LANDMARKS PRESENTATION

NEW YORK CITY LANDMARKS PRESERVATION COMMISSION
REVISED 10/30/25

83 HORATIO STREET
NEW YORK, NY, 10014

2 10/30/25 PROPOSED BUILDING SECTION
1/16" = 1'-0" PROPOSED DESIGN

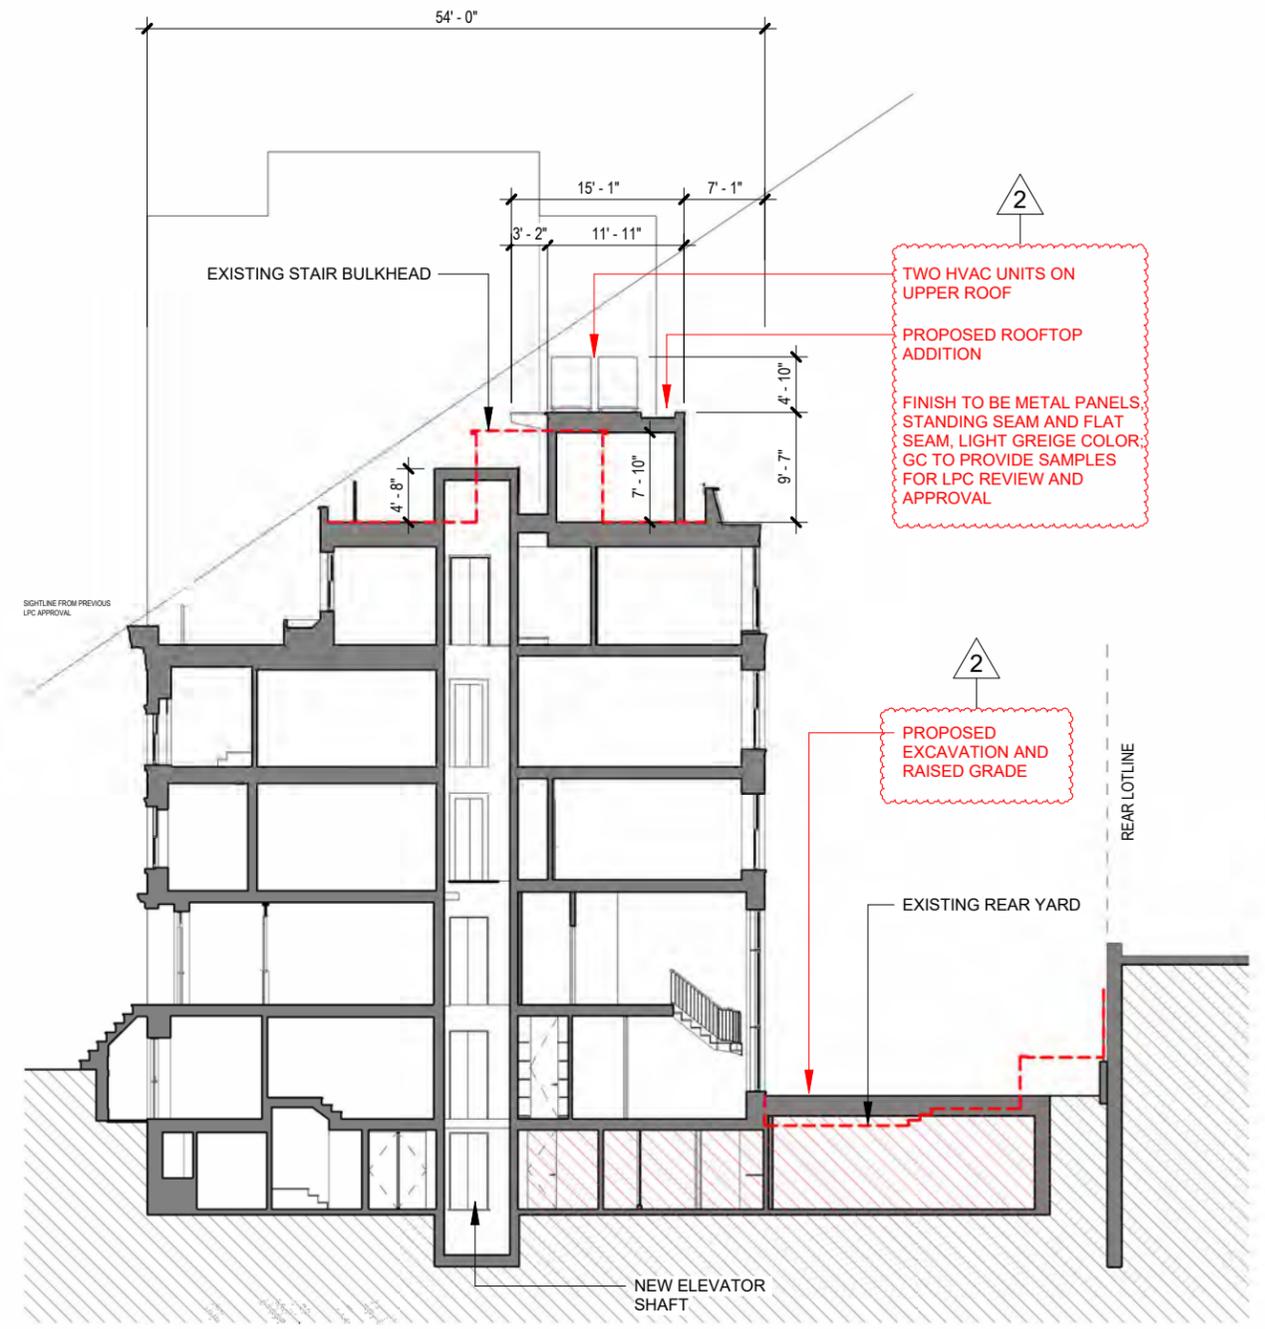
- EXCAVATIONS AT CELLAR LEVEL;
 (rev103025: **SHALLOWER EXCAVATIONS AT REAR; NO NEW EXCAVATIONS AT EXISTING CELLAR FOOTPRINT EXCEPT AT ELEVATOR SHAFT**)
- NEW REAR YARD DESIGNS;
- A NEW DOUBLE-HEIGHT OPENING AT THE REAR FACADE AT GARDEN (BASEMENT) LEVEL;
 (rev103025: **SIMPLIFIED REAR FACADE, PRESERVE BRICK PIERS**)
- A NEW ELEVATOR ON THE INTERIOR (ELEVATOR OVERRUN AT ROOF LEVEL, NOT VISIBLE TO STREET OR FROM HIGHLINE)
- MODIFY AND ENLARGE EXISTING STAIR BULKHEAD (LIMITED VISIBILITY FROM GANSEVOORT SQUARE ONLY)
 (rev103025: **DECREASED SIZE; MOVE HVAC UNITS; DELETE UPPER ROOF ACCESS AND RAILING**)

3 10/30/25 PROPOSED REAR YARD PLAN
1/8" = 1'-0"

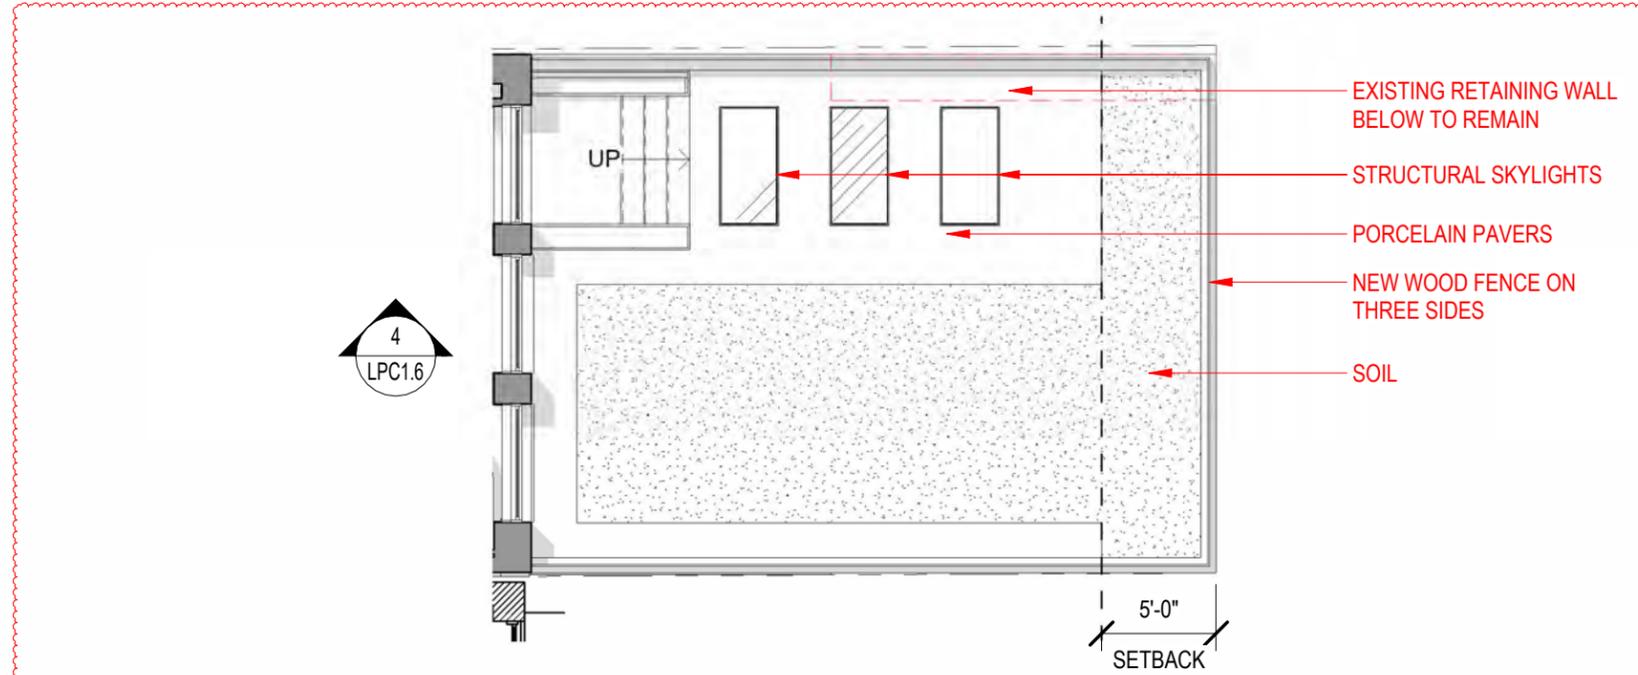
NOTE: EXISTING CELLAR IS SHOWN 2 1/2" LOWER THAN ACTUAL IN 5/6 PRESENTATION DUE TO SURVEY ERROR. CORRECTED SIZE SHOWN IN 10/30 PROPOSAL.

3 PROPOSED ROOF PLAN
1/8" = 1'-0"

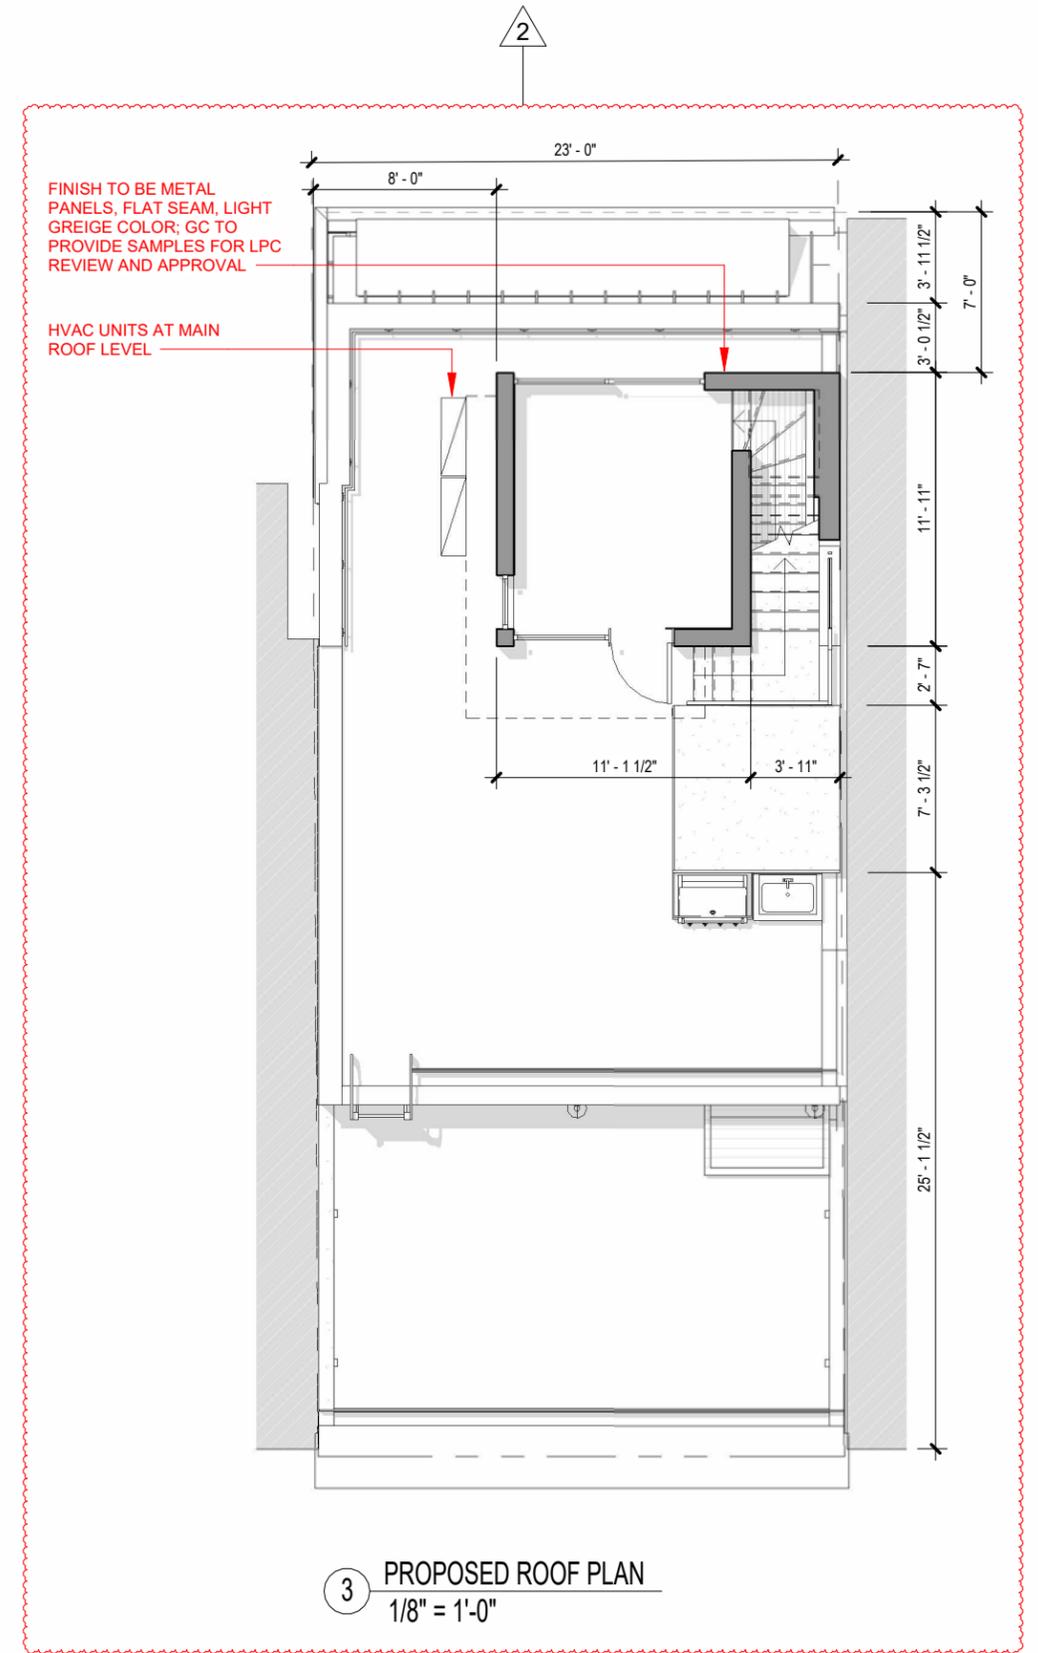
- 2
- TWO HVAC UNITS AT UPPER ROOF LEVEL
 - NO ACCESS TO UPPER ROOF; NO RAIL
 - FLAT SEAM METAL PANELS, LIGHT GREIGE COLOR; GC TO PROVIDE SAMPLES FOR LPC REVIEW AND APPROVAL
 - TWO HVAC UNITS AT MAIN ROOF LEVEL IN SIDE AREA WAY

③ 10/30/25 PROPOSED FRONT PERSPECTIVE - SOUTH

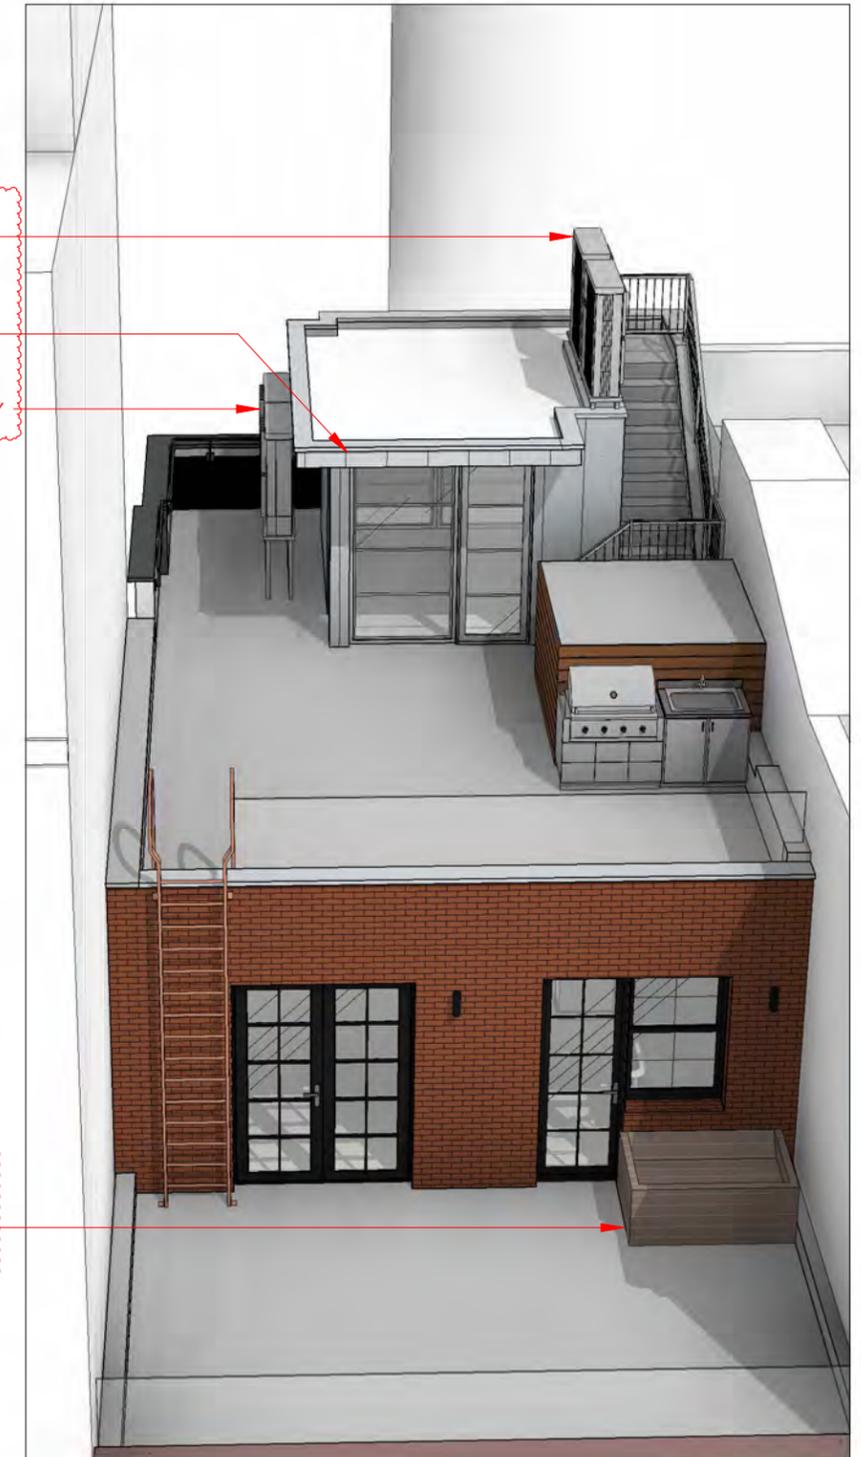
△ 2
 (NO CHANGE TO EXISTING PLANTER BOX; NO NEW SKYLIGHT)

4 NEW MOCKUP 10/30/25 - ROOF PLAN DIAGRAM
1/8" = 1'-0"

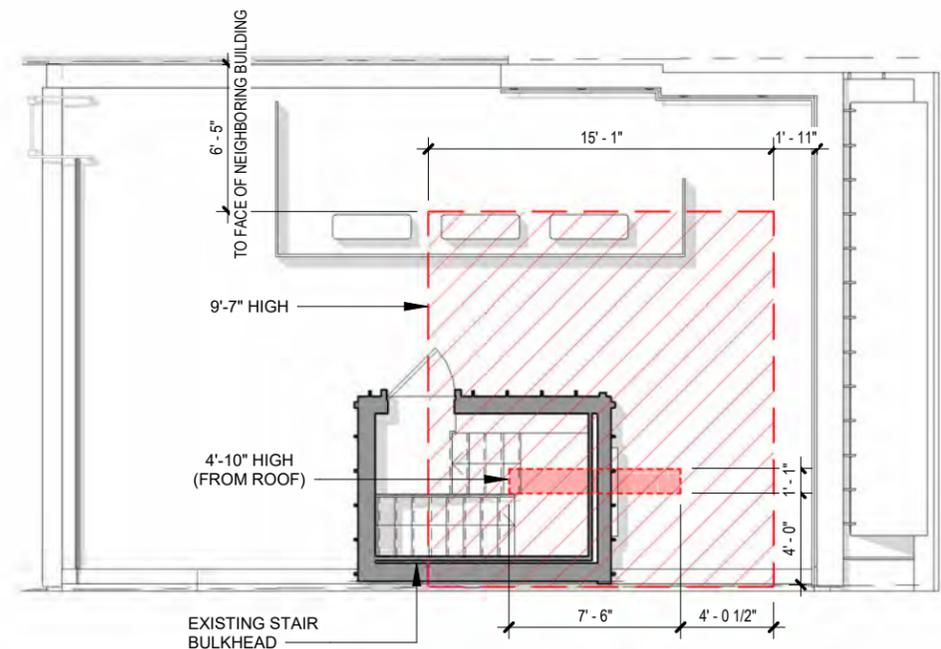
rev103025: NO ACCESS TO UPPER ROOF, NO RAIL
